Panel Report

**Melbourne Planning Scheme Amendment C270
Central City Built Form Review**

26 October 2016

Figure 8 International comparison of allowable FAR (base without any uplift)²⁰

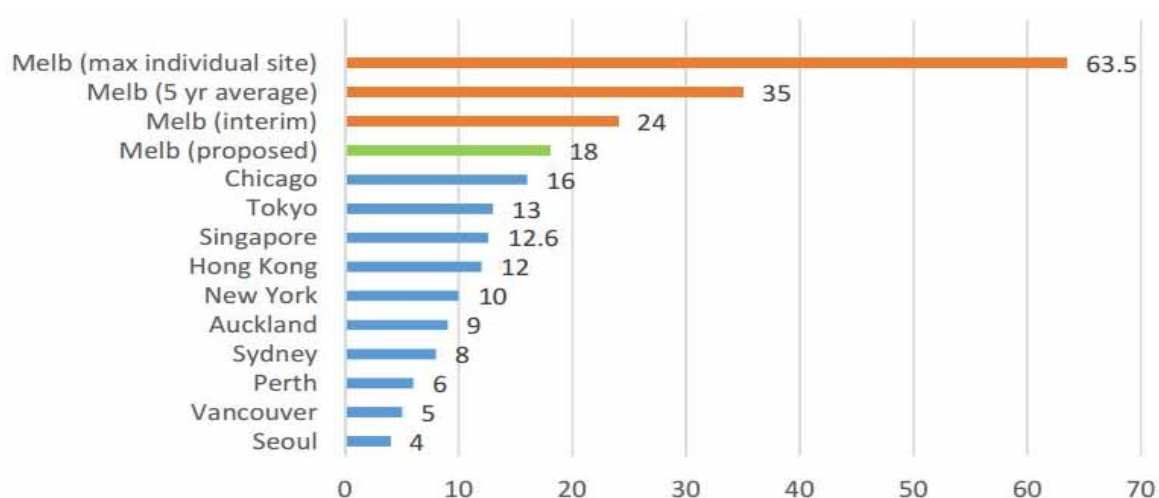
The Panel remains concerned, however, that an 18:1 FAR is high in comparison with other cities (especially if unlimited FAU applies). The Minister's own evidence reveals this and this was reinforced with the illustration shown in Figure 8, as to where Melbourne sits in terms of FAR when benchmarked globally.

Figure 9 Map of street wall heights in the Amendment area³⁹

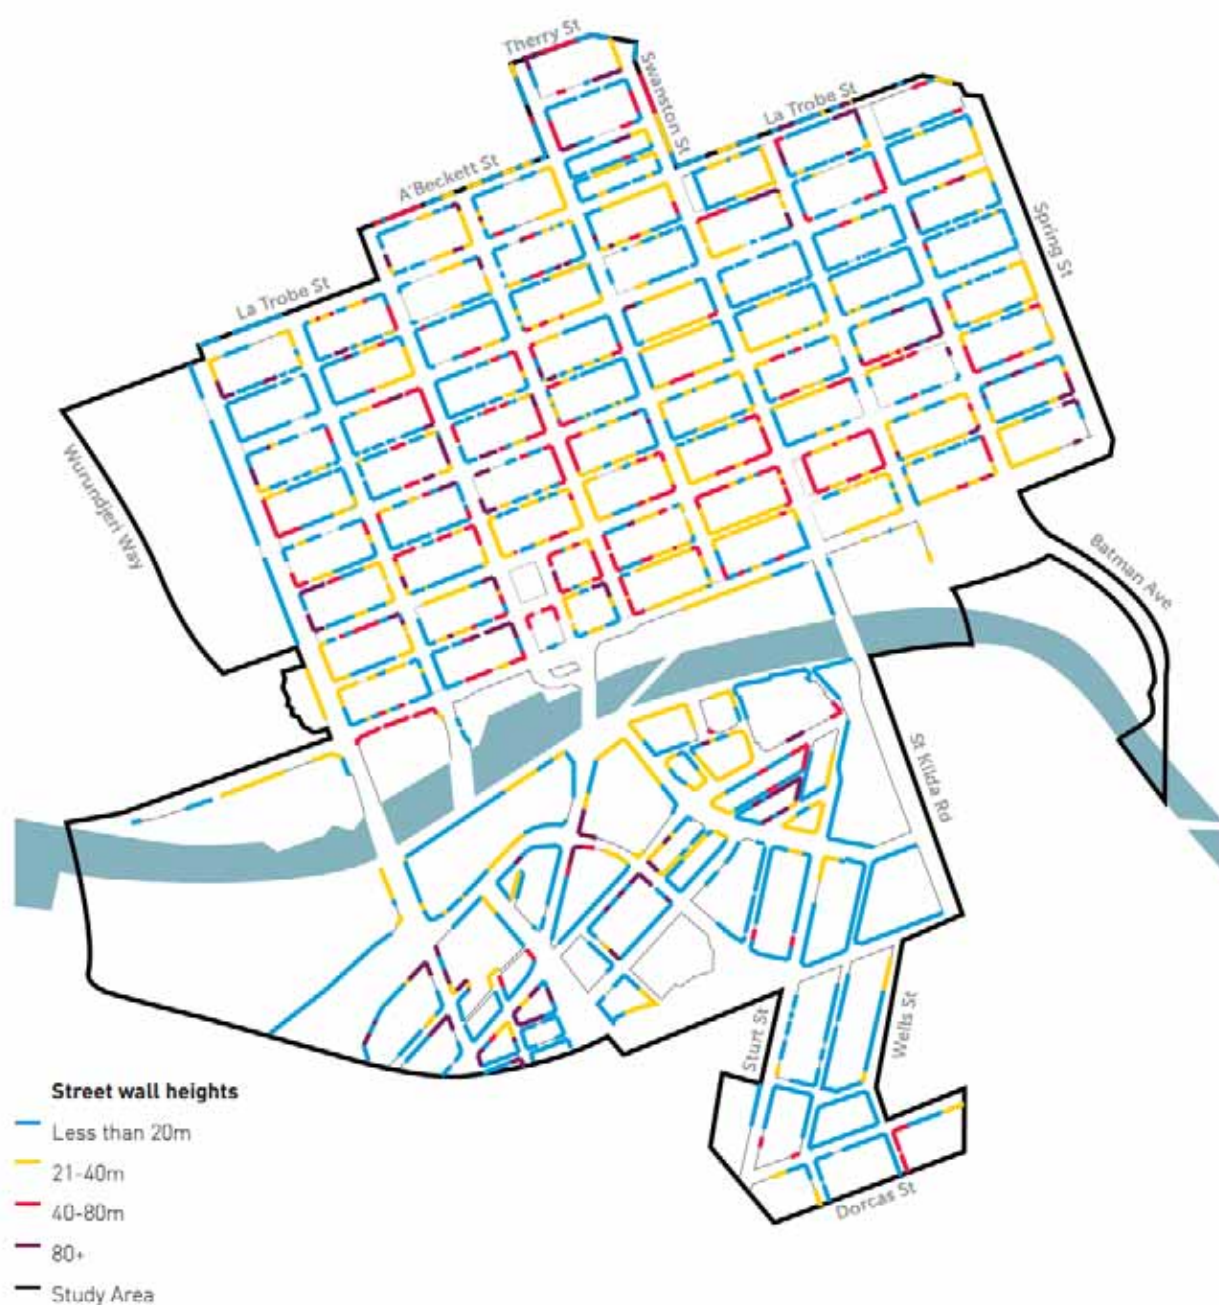
It was Mr Sheppard's evidence that the preferred street wall height should be amended to include heights up to 30 metres in main streets. Ms Brennan submitted that the combination of a preferred street wall height of 20 metres and a modified street wall height of 40 metres maximum (and up to 80 metres in certain circumstances) in DDO10 was arrived at following what is perhaps:

The first detailed analysis of existing street wall heights in the Central City. This exposed the myth of 40m as the 'Melbourne' street wall height. In fact, of the total length of street wall surveyed, only 10 percent was between 30 and 40 metres in height, while 54 percent was 20 metres or lower in height.

- Add the following built form outcome regarding street wall: *“Maintenance of the prevailing street wall height and vertical rhythm of the street”*.
 - Include in the ‘Preferred Requirement’ column, a street wall height range of 15-30 metres in main streets and 7 – 20 metres in streets.

Figure 18 Tower separation at 8 metres and 10 metres⁵⁵

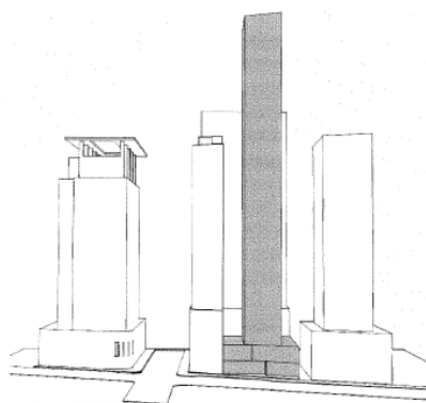
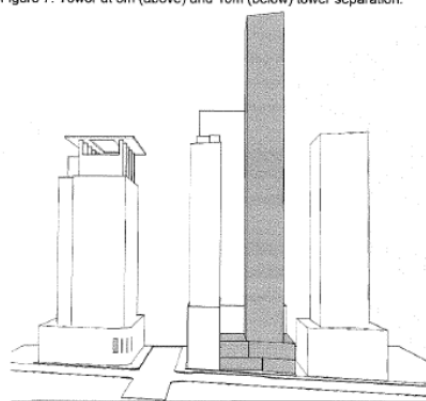
Ms Macklin raised issues on tower separation, blank walls, daylight and shadowing. Having regard to the Wood and Grieve report, Ms Macklin argued that the existing built form context of sites, site orientation and proposed building all played a role in sunlight to the street. When questioned by the Panel on this, Ms Macklin agreed with the daylight assessment criteria put forward. She disputed the Minister’s assertion of a ‘wall of towers’ being erected if the tower separation controls were relaxed or discretionary. It was her submission that:

There must be some acknowledgement of the impost of meeting minimum 10m tower setbacks on one site in terms of equitable development outcomes... The new controls should not seek to provide a ‘first in best dressed’ with respect to existing and approved development, to the total burden of adjacent sites.

Figure 21 Eastern side of Elizabeth Street exhibiting SCA traits, western side showing significant height and modern development⁶²

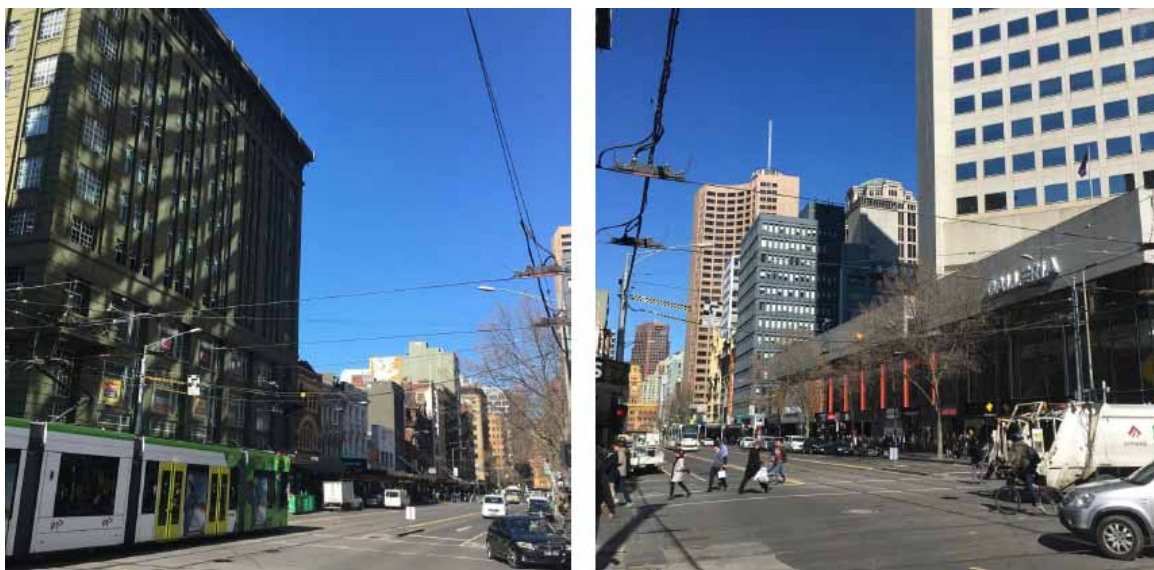
Wren as there already exists a significant development and built form to the Galleria precinct. This is highlighted in Figure 19.

- The part of the precinct containing the Galleria Plaza and associated buildings is not considered worthy of a SCA designation.
- The land at 385 Bourke Street and as shown at Figure 13, should be deleted from DDO2 Area A1 and included within DDO10.
- Remaining land shown on the plan is to be included within DDO2-A1 with the exception of Melbourne Central.

- **Deleting the land at 385 Bourke Street as shown in Figure 13 of this report and retain it in Design and Development Overlay Schedule 10.**
